Scientific Analysis Administrative Change Notice

1. Document Number:	ANL-DSD-MD-000001	2. Revision:	01	3. ACN:	01
4. Title:	Aqueous Corrosion Rates for Waste Package Materials				
5. No. of Pages Attached:	11

Figure 6-21. Corrosion Rates of Titanium Grades 2, 5, 7, 16, and 24 in Boiling HCl

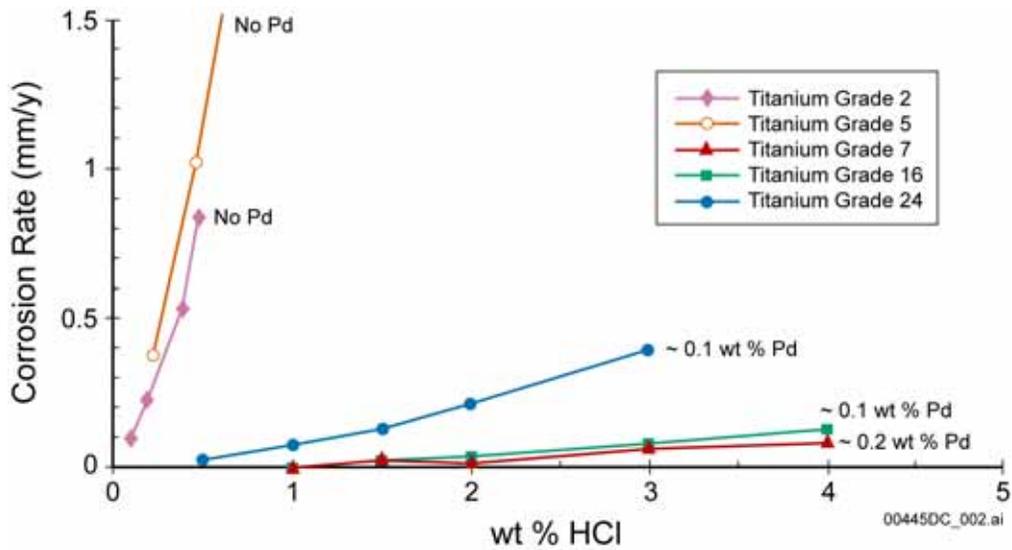
1. Document Number:	ANL-DSD-MD-000001	2. Revision:	01	3. ACN:	01
4. Title:	Aqueous Corrosion Rates for Waste Package Materials				
6-40	<p>Change figure number.</p> <p>Figure 6-22. Corrosion Rates of Titanium Grades 2, 5, 7, 16, and 24 in Boiling HCl</p> <p>Change to read:</p> <p>Figure 6-21. Corrosion Rates of Titanium Grades 2, 5, 7, 16, and 24 in Boiling HCl</p> <p>This change was self-identified.</p>				
6-40	<p>Editorial correction.</p> <p>Figure 6-22 “Corrosion Rates of Titanium Grades 2, 5, 7, 16, and 24 in Boiling HCl”, change footnote:</p> <p>Source: BSC 2004 [DIRS 169847] (Figure 10). To Source: BSC 2004 [DIRS 169847], Figure 10.</p> <p>This change was self-identified</p>				
6-40	<p>Text added for clarification.</p> <p>Section 6.5.2 “Titanium Grade 24”, page 6-40, insert the following text after the figure to read:</p> <p><i>General Corrosion and Localized Corrosion of the Drip Shield</i> (BSC 2004 [DIRS 169845]) plots all of the 2.5-year weight-loss data (vapor, aqueous, and water line) for Titanium Grade 7 from DTN: LL030410012251.056 [DIRS 169583] in the CDF shown in Figure 6-22. The corrosion rate from all weight-loss specimens at the 85% percentile of the cumulative distribution function is about 15 nm/yr.</p> <p>Note: This text is moved from page 6-39 to page 6-40 without any change to the content.</p> <p>This change was self-identified.</p>

Figure 6-22. Titanium Grade 7 Weight-Loss Corrosion Rates after 2.5 Years

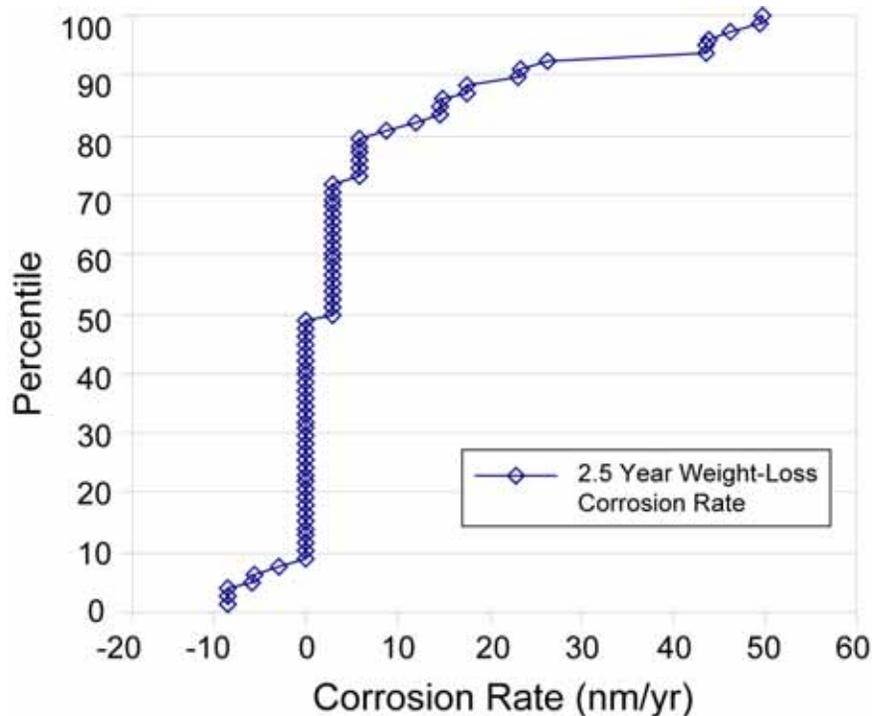
1. Document Number:	ANL-DSD-MD-000001	2. Revision:	01	3. ACN:	01
4. Title:	Aqueous Corrosion Rates for Waste Package Materials				
6-39	<p>Removed figure.</p> <p>Delete Figure 6-21 “ Titanium Grade 7 Weight-Loss Corrosion Rates after 2.5 Years”, and the source from page 6-39.</p> <p>This change was self-identified.</p>				
6-39	<p>Added text for clarification (Correct DIRS as appropriate)</p> <p>Section 6.5.2 “Titanium Grade 24”, 3rd paragraph, change:</p> <p>The corrosion rates of Titanium Grades 2 (Titanium with no Pd) and 5 (Ti-6Al-4V with no Pd) in hydrochloric acid solutions, a very aggressive test media for titanium alloys, are shown in Figure 6-22 along with those of Titanium Grades 7, 16, and 24. The addition of 0.04 to 0.08 wt % of Pd to Titanium Grades 2 and 5 (to produce Titanium Grades 16 and 24) significantly improves the corrosion resistance of the alloy as demonstrated in Figure 6-22. From Figure 6-22, it can be seen that the corrosion rate of Titanium Grade 24 is about five times higher than that of Titanium Grade 7 in 3% boiling HCl. On this basis, a conservative estimate of the corrosion rate of Titanium Grade 24 in less aggressive repository environments would be a corrosion rate five times higher than that of Titanium Grade 7.</p> <p>To</p> <p>The corrosion rates of Titanium Grades 2 (Titanium with no Pd) and 5 (Ti-6Al-4V with no Pd) in hydrochloric acid solutions, a very aggressive test medium for titanium alloys, are shown in Figure 6-21 along with those of Titanium Grades 7 (0.12 – 0.25 wt% Pd), 16, and 24. The addition of 0.04 to 0.08 wt % of Pd to Titanium Grades 2 and 5 (to produce Titanium Grades 16 and 24) significantly improves the corrosion resistance of the alloy as demonstrated in Figure 6-21. Handbook data (Schutz and Thomas 1987 [DIRS 144302], Table 7, p. 679) indicate that the corrosion rate of Titanium Grade 5 is approximately four times that of Titanium Grade 7 in boiling 25% HNO₃ (a much more aggressive corrosion environment than the repository environment). Since the purpose of Pd alloying of titanium is to help maintain the passivity of a titanium alloy (see BSC 2005 [DIRS 174995], Section 6.2.7), the general corrosion rate of Titanium Grade 24 (i.e., the palladium containing analog of Titanium Grade 5), should be lower than that of Titanium Grade 5. Therefore, the general corrosion rate for Titanium Grade 24 can be conservatively estimated to be 5 times that of Titanium Grade 7.</p> <p>Figure 6-21, shows that the corrosion rate of Titanium Grade 24 is about five times higher than that of Titanium Grade 7 in 3% boiling HCl, further validating the use of Titanium Grade 7 corrosion rates with an applied multiplier of 5. On this basis, a conservative estimate of the corrosion rate of Titanium Grade 24 in less aggressive repository environments would be five times higher than that measured for Titanium Grade 7.</p> <p>This change was identified in NRC Summary Letter from Audit BSC-BQAP-05-07</p>

6-40	<p>Add figure.</p> <p>Insert Figure 6-22 entitled “Titanium Grade 7 Weight-Loss Corrosion Rates after 2.5 Years” and add a footnote to the figure to read:</p> <p>Source: BSC 2004 [DIRS 169845], Figure 26.</p> <p>Note: This figure is moved from page 6-39 to page 6-40. The only change to the figure is the figure number. The figure number changed from Figure 6-21 to Figure 6-22.</p> <p>This change was self-identified.</p>
